Merged Document Report

Application No.: PL8877

Description :	
Address :	
Record Type :	PLAT

Document Filename
25081_Riverstone Ph1_02-06-2026.pdf

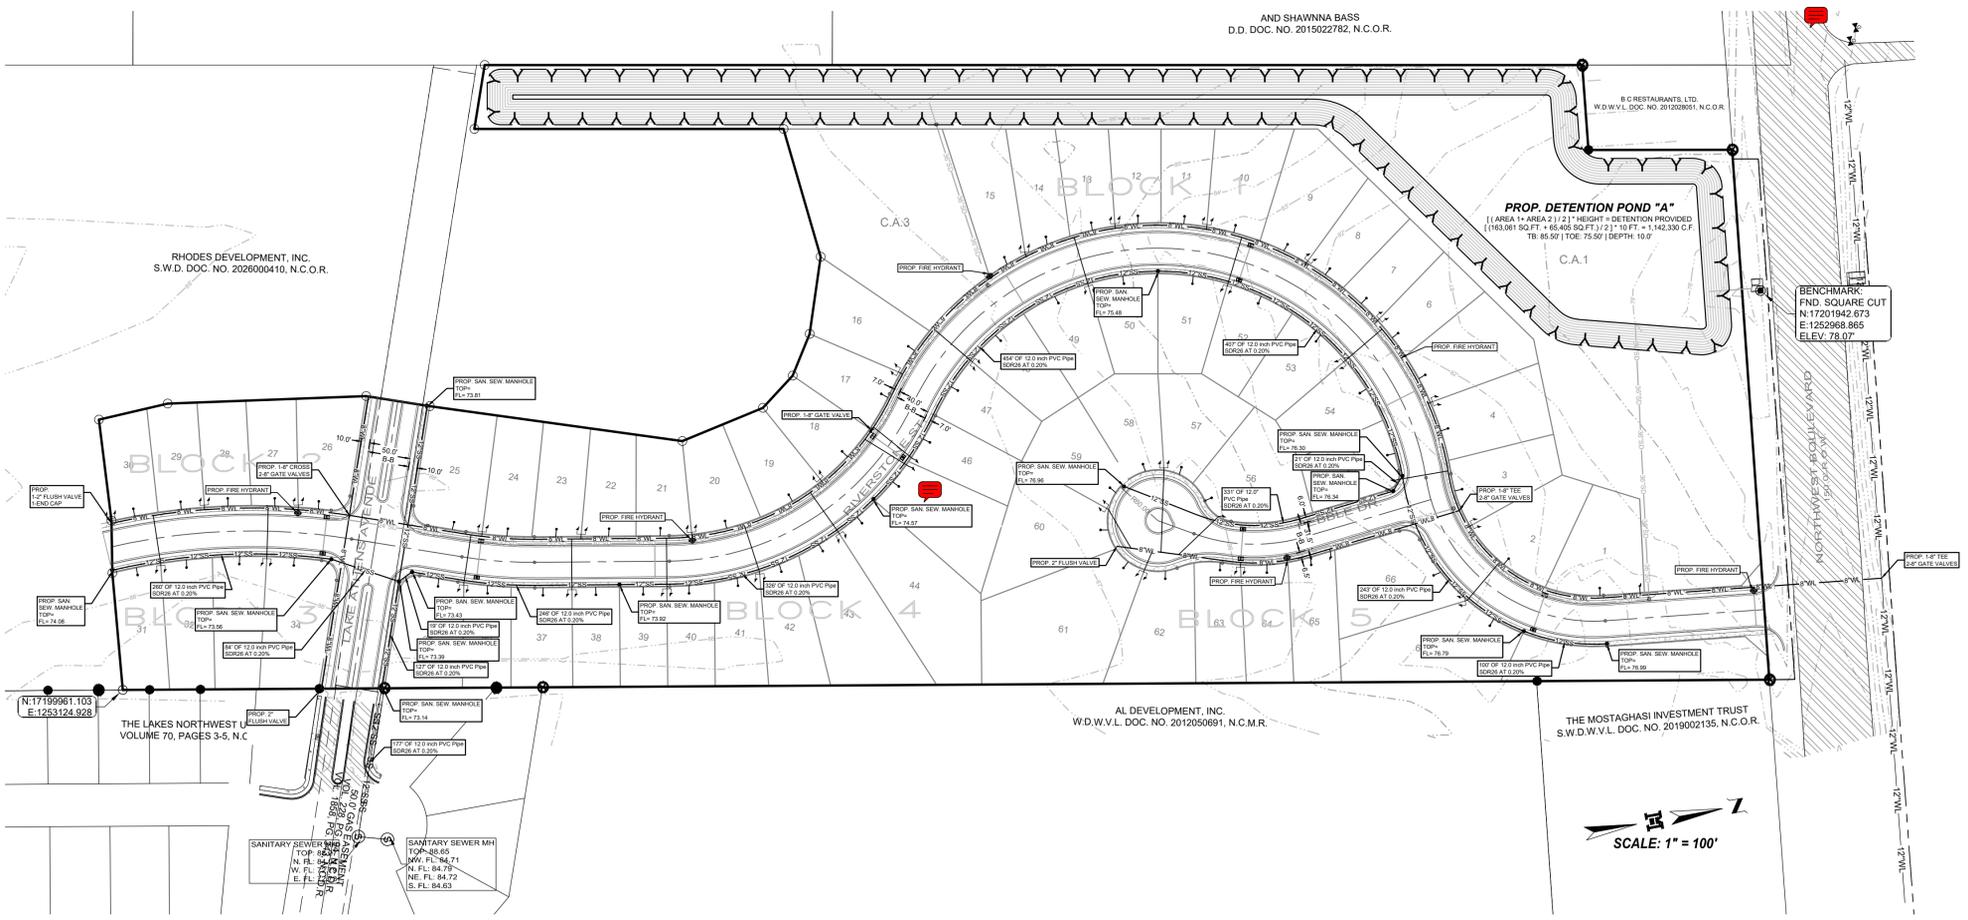
18	U001	Note	Bria Whitmire : DS	Closed	Details of service connections around cul d sac to be further addressed on construction plans.	
24	U001	Note	Mina Trinidad : DS	Closed	(Informational) Gas Department has no comment.	
25	U001	Note	Mina Trinidad : DS	Closed	(Informational) Equistar Pipeline will not be involved, no comment.	
52	U001	Note	Mina Trinidad : DS	Closed	(Informational) AEP Distribution has no comment.	
53	U001	Note	Mina Trinidad : DS	Closed	CCW: (John Gonzalez) Water Water construction is required for platting (UDC 1.2.1.D & 8.2.6; Water Distribution Standards). Additional comments of the proposed water plan & profile to be provided during Public Improvements Phase. Wastewater Wastewater construction is required for platting (UDC 1.2.1.D & 8.2.7; Wastewater Collection System Standards). Additional comments of the proposed wastewater plan & profile to be provided during Public Improvements Phase.

Comment ID	Page Reference	Annotation Type	Author : Department	Status	Review Comments	Applicant Response Comments
54	U001	Note	Mina Trinidad : DS	Closed	AEP: 02/05/26 Update: No above ground improvements are allowed 100' within our ROW (50 ft from centerline). (See documents titled "CE Jolley Easement" in attachments). (Ronika Moralez) AEP Transmission does have an overhead power line but I believe it is not in Phase 1. I can send you my comments when I locate the easement.	
14	U002	Note	Bria Whitmire : DS	Closed	Minimum Slope is 3:1	
15	U002	Note	Bria Whitmire : DS	Closed	Provide Cross Section for all street types, including the 50' ROW, 60' ROW, 76' ROW and cul d sacs	
26	U002	Note	Justin Phung : STREET	Closed	PW STR: Per UDC Sec. 3.1.6.B, please provide typical cross section of proposed streets and/or Mobility Plan facilities consistent with latest UDC and Infrastructure Design Manual (On Preliminary Plat and Final if not provided on a previous Preliminary plat).

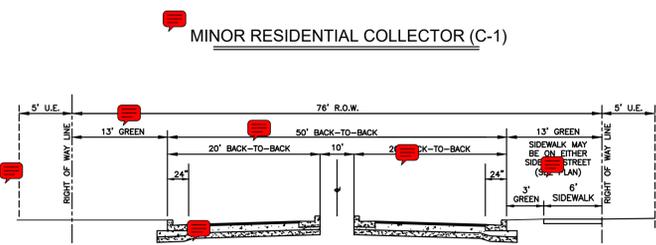
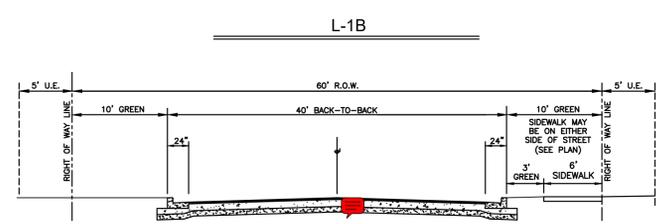
27	U002	Note	Justin Phung : STREET	Closed	PW STR: The developer shall be required to utilize the most stringent of sections per classification of roadway without a Geotech report validating the soil type. Please refer to IDM when constructing pavement section.	
28	U002	Note	Justin Phung : STREET	Closed	PW STR: For typical street section details, please denote planned street classification per UDC 8.2.1.B standards	
29	U002	Note	Justin Phung : STREET	Closed	PW STR: Please provide typical street section specifications on pavement section materials and thicknesses.	
30	U002	Note	Justin Phung : STREET	Closed	PW STR: Per IDM Table 6.3.5H, the road section cross-slope from the crown to the gutter shall be a consistent 2% minimum.	
31	U002	Note	Justin Phung : STREET	Closed	PW STR: Per IDM Table 6.3.5I, Only TxDOT Type A, Gr. 1-2 crushed limestone base allowed on City roadway projects without pre-approval.

32	U002	Note	Justin Phung : STREET	Closed	PW STR: Per IDM table 6.3.5H, the treated subgrade and flexible base shall extend at least 2 feet beyond the back of curb.	
33	U002	Note	Justin Phung : STREET	Closed	PW STR: Per IDM Table 6.3.5J, One coarse surface treatment/underseal would be required between the base and asphalt pavement.

62	U002	Note	Justin Phung : STREET	Closed	PW STR: Informational - For PI, please provide geotech report for determining validity of street sections.	
64	U002	Note	Justin Phung : STREET	Closed	PW STR: Is it planned to have the median for the 76' ROW match what is existing for Lake Athens Avenue? Please coordinate with Public Works Stormwater Department to determine the construction of these.
